BLOOMINGTON HISTORIC PRESERVATION COMMISSION

AGENDA

COA-17-33

212 S. Grant St. (Greater Restaurant Row)
Petitioner: Annex Student Living

26

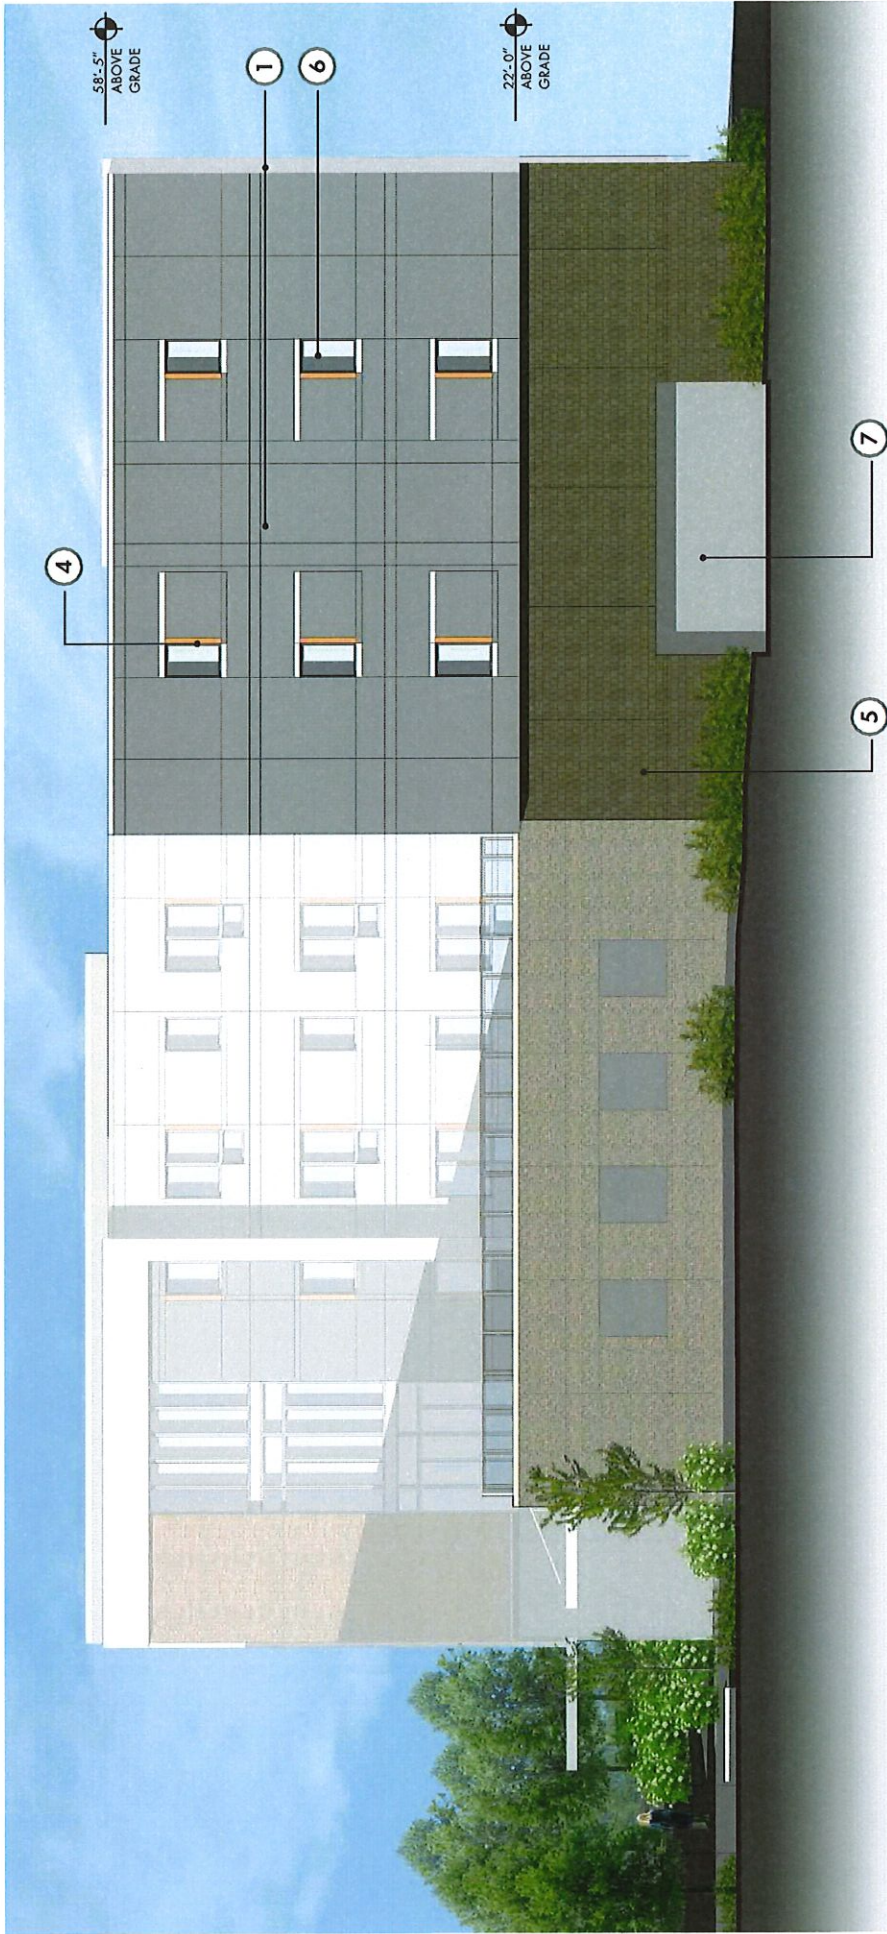
Standard 9 from the SOI Standards notes three important review considerations for new infill construction: “characteristics of the property, differentiation of the new work from the old, and compatibility with existing fabric in terms of materials, features, size, scale, and proportions and massing.” Things to be considered in context with the rest of the historic district are how the new construction fits by site placement, height, massing, scale, materials, development patterns and architectural characteristics such as ornamentation and fenestration. The portion of the project in our purview breaks away

from many of the district's characteristics such as the rhythm of the residential form and fenestration, material connectivity, and residential character. This district's period of significance is primarily the late 1800s and early 1900s district. This proposed project shows no connection to the district other than having a residential feel front yard street/pedestrian connection adjacent to the house on 212 S. Grant St. As the district's character as a single family residential pattern is still well established, staff is recommending denial of the permit according to incompatibility for the aforementioned criteria within the Greater Restaurant Row Historic District.
